This Service Information bulletin supersedes SI B13 07 12 **dated April 2014.**

N63 and S63 Engine: High-pressure Fuel Injector Replacement Procedures

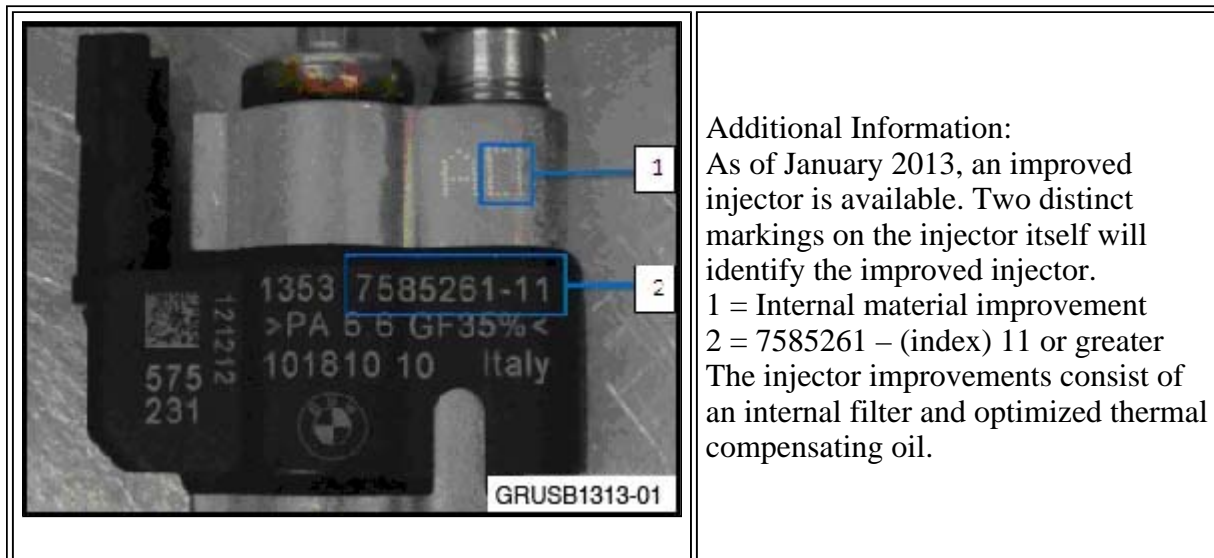
For example, if the engine has a misfire on cylinder 1, replace the injectors for cylinders 1-4 if those **injectors are not already index 11 or higher**.

If the **injectors** on that bank are **already index 11 or higher**, only replace the injector on the faulty cylinder.

Use **P/N 13 53 8 616 079** when replacing the injector(s).
